DOCUMENT CHANGE NOTICE (DCN)

DOCUMENT No. (DOC-REV-GP. ID)	TITLE	NEW REV.
D000064-B-D	SENSOR/ACTUATOR HEAD, LONG, SMD, MACOR	C
D000066-C-D	SENSOR/ACTUATOR HEAD, SHORT, SMD, MACOR	D

CALIFORNIA INSTITUTE OF TECHNOLOGY
MASSACHUSETTS INSTITUTE OF TECHNOLOGY

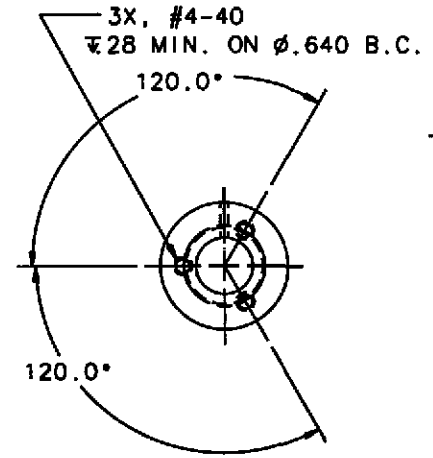
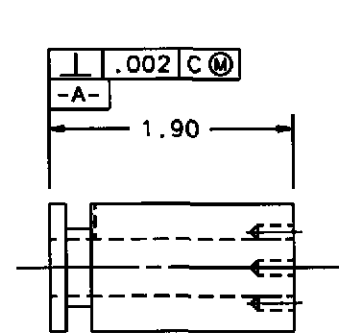
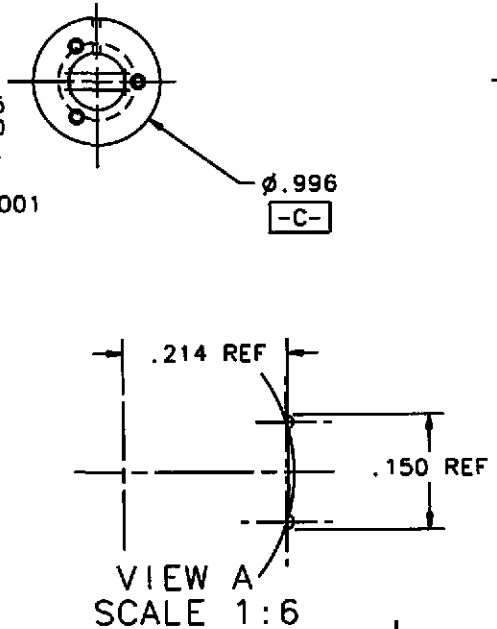
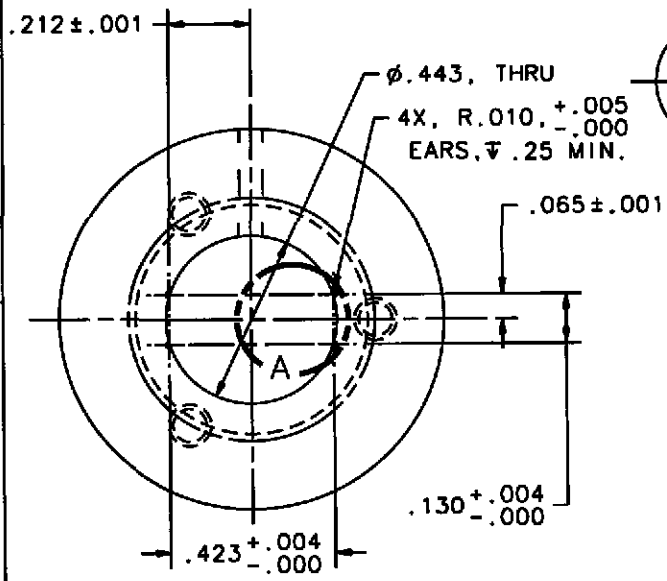
CHANGE DESCRIPTION (FROM/TO): For both drawings, remove notes 1 and 4.
electronically submitted

REASON FOR CHANGE: Note 1 is covered with note 2. Revised assembly (D000069 and D000180) and circuit boards (D000194 and D000195 along with D000204 and D000205) make masking unnecessary.

REV	DATE	DRAWN BY	CHECKED	DCC	DCN/DESCRIPTION
A	5/9/00	J. Romie			E000240/INITIAL RELEASE
B	5/26/00	J. Romie			E000264/ADD TOLERANCES
C	6/19/00	J. Romie			E000326/REMOVE NOTES 1, 4
